**WIBSEY PARK AVENUE & FARFIELD AVENUE, BRADFORD, TRAFFIC CALMING
MEASURES - OBJECTIONS**

This report considers objections received to recently advertised proposals for traffic calming measures on Wibsey Park Avenue & Farfield Avenue, Bradford.

- 2.3 The location of the proposed traffic calming measures is shown on drawing nos. HS/TRSS/105399/CON-1B & CON-2B, attached as Appendix 1.
- 2.4 An initial consultation was carried out and feedback was received from some residents, the formal consultation was then advertised between 26 January 2023 and 17th February 2023. At the same time consultation letters and plans were delivered to residents fronting Wibsey Park Avenue and Farfield Avenue (approximately 336 letters were delivered). This resulted in 12 objections (2 from the same household) and 11 responses showing support for the proposals.

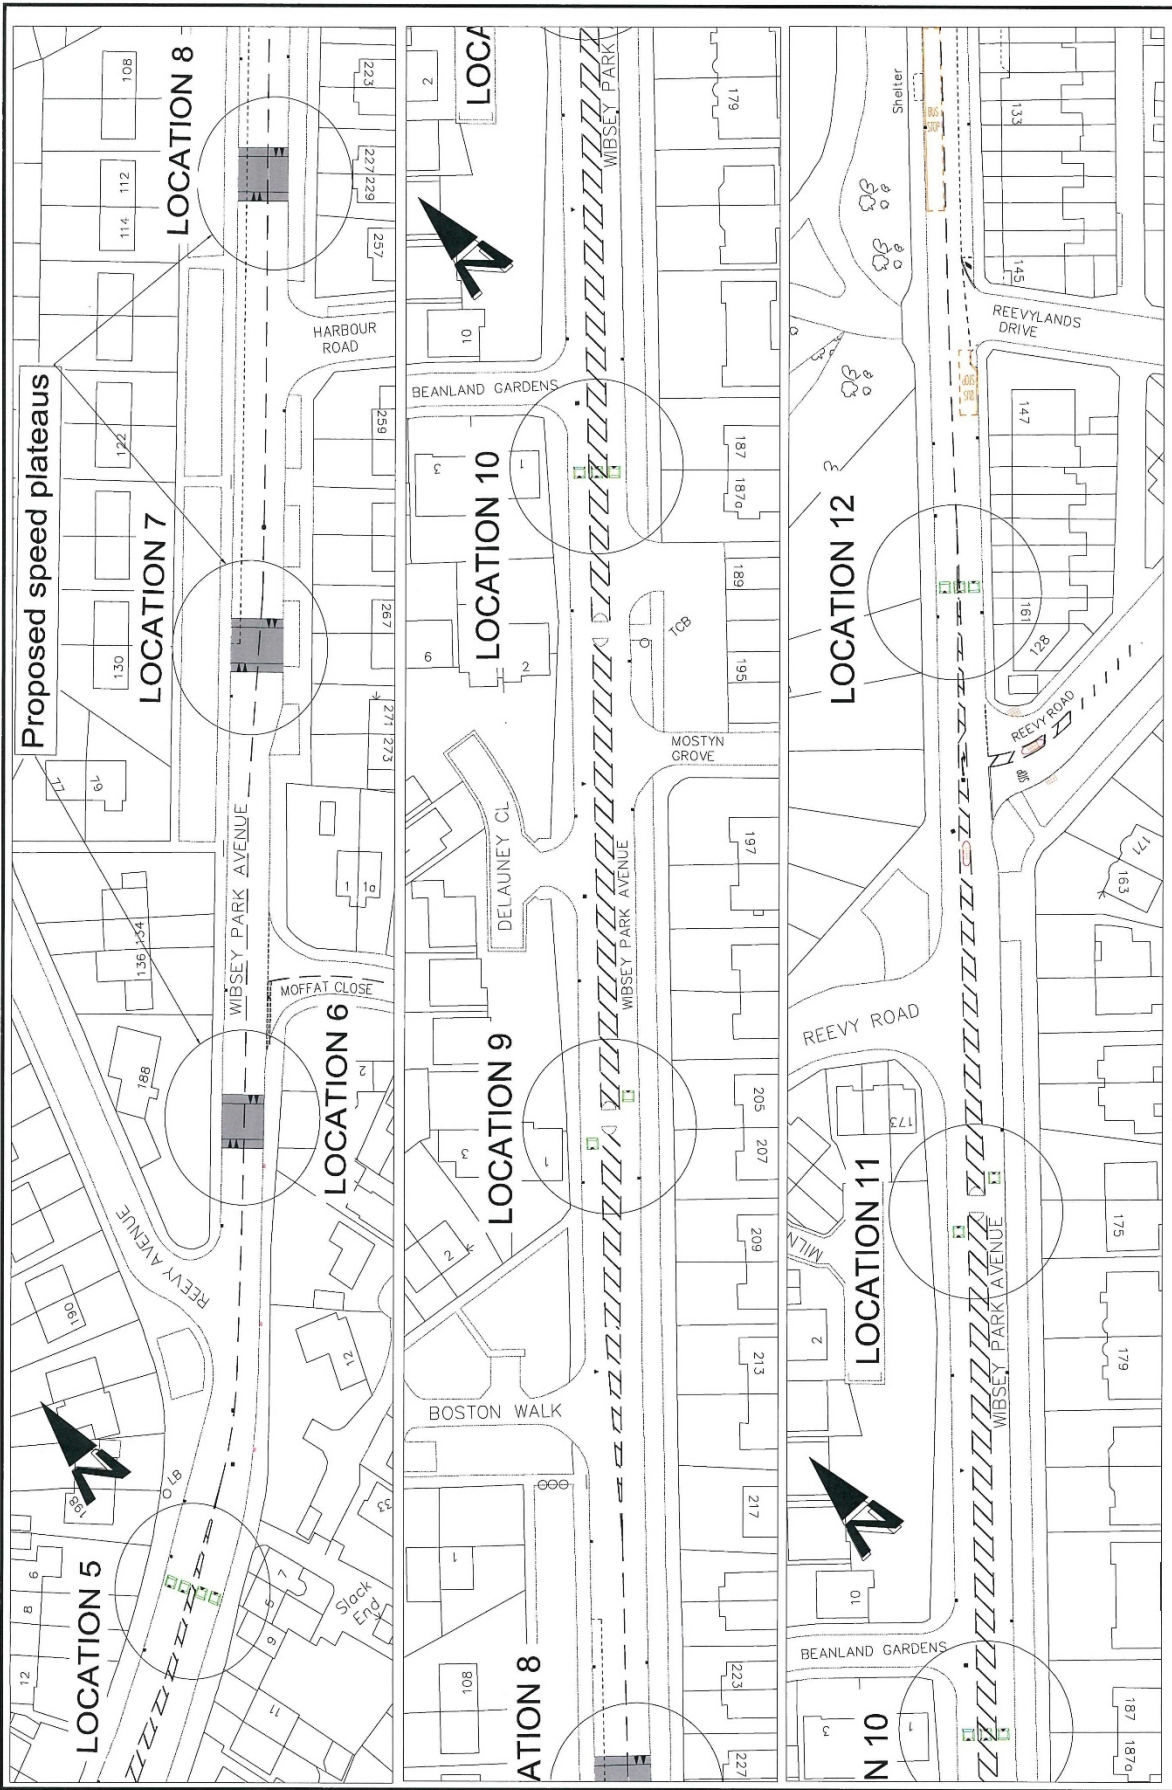
<p><u>Objector No. 3</u></p> <p>The objector states that the plans provided by you show speed humps directly outside their driveway and they oppose the location of the humps as they will impinge on access and egress to the driveway of their property. It is proposed the location of these humps be moved eastwards towards the junction at Reevy Avenue, in a location that does not affect driveway access to the properties on this section of road. There are ample locations available in</p>	<p>Following the initial consultation, a review of the location for the traffic calming feature was undertaken and was moved slightly eastwards which would avoid being directly in front of any driveways. This change is reflected in the latest drawing HS/TRSS/105399/CON-2B</p>

<p>this area to facilitate this.</p> <p>It is felt the location of the humps directly outside their driveway will have a detrimental effect on theirs and other road users' safety which is inconsistent with the intended purpose of the speed calming measures.</p>	
<p><u>Objector No. 4</u></p> <p>I have some concerns regarding the proposals.</p> <ol style="list-style-type: none"> 1. Increased pollution from vehicle exhausts due to decreasing/increasing speed. 2. Increased pollution from vehicle tyres due to increased breaking. 3. Increased noise pollution due to increase in breaking, acceleration, and driving across the speed bumps. 4. Increased wear and tear on the vehicles used and owned by the local residents. <p>Has a survey been done in regards to the above and other factors that will have an impact on the environment, animal and fauna, and local residents?</p> <p>As it stands I object to the proposals until I see a survey which highlights the negative impact the bumps may have and how that negative impact may be mitigated.</p> <p>I am also concerned with how this may impact my ability to obtain planning</p>	<p>With regards to the air quality, there have been conflicting studies as to whether traffic calming increases or decreases pollutants. However, it is advised that particular attention would need to be given to the balance between reductions in injury accidents and increases in vehicle emissions. In the previous 5 years the accident records show that there have been 12 accidents of which 2 have been serious, along Wibsey Park Avenue and Farfield Avenue. 4 of these accidents are recorded at the Reevy Road junction.</p> <p>The scheme should have a neutral impact on noise pollution.</p> <p>All traffic calming features are built to national guidelines. Vehicles travelling over road humps at appropriate speeds should not suffer damage, provided the humps conform to the Highways (Road Hump) Regulations. A study in to the effect of repeatedly traversing road humps on vehicles (Kennedy et al., 2004e) showed no damage to any of the vehicles was seen, despite repeated passes at speeds up to 40 mph. However, suspension geometry checks revealed some minor changes in the suspension systems tested. Further testing showed there was no continuing trend for the suspension to move further out of specification; but stayed within the manufacturer's tolerances.</p> <p>Officers have obtained the objectors address and there are no traffic calming features within</p>

<p><u>Objector No. 11</u></p> <p>We have concerns with the cushions at location No.4 The concerns are as</p>

<p>below.</p> <ol style="list-style-type: none">1. At the moment we have problems with people parking and blocking our drive and feel that with the position of cushions at no 4 may cause people to park further down and cause further problems for us to get into and out of our drive.2. The position of no 4 may cause noise as it is quite near to where our bedroom is.3. When people go over the cushions they slow down and then pick up speed when they have gone over the cushion and concerned this may also impact on use getting in and out of our drive. <p>Not sure if the plateau would be a better alternative.</p>	<p>Traffic calming features do not hamper the parking of vehicles. Therefore parking arrangements should not change where they have been proposed.</p> <p>The scheme should have a neutral impact on noise pollution.</p> <p>With vehicles slowing down approaching the traffic calming feature, we would regard the access in to and out of the drive would become easier, in comparison to if there were no traffic calming features close to the driveway.</p>

- Firstly both [REDACTED] welcome the introduction of speed calming measures on this stretch of road and consider them long overdue. The plans provided by you show speed humps directly outside their driveway I refer to location 5 on the plan provided. [REDACTED] oppose the location of the humps as they will impinge on access and egress to the driveway of their property. It is proposed the location of these humps be moved eastwards towards the junction at Reevy Avenue, in a location that does not affect driveway access to the properties on this section of road. There are ample locations available in this area to facilitate this.
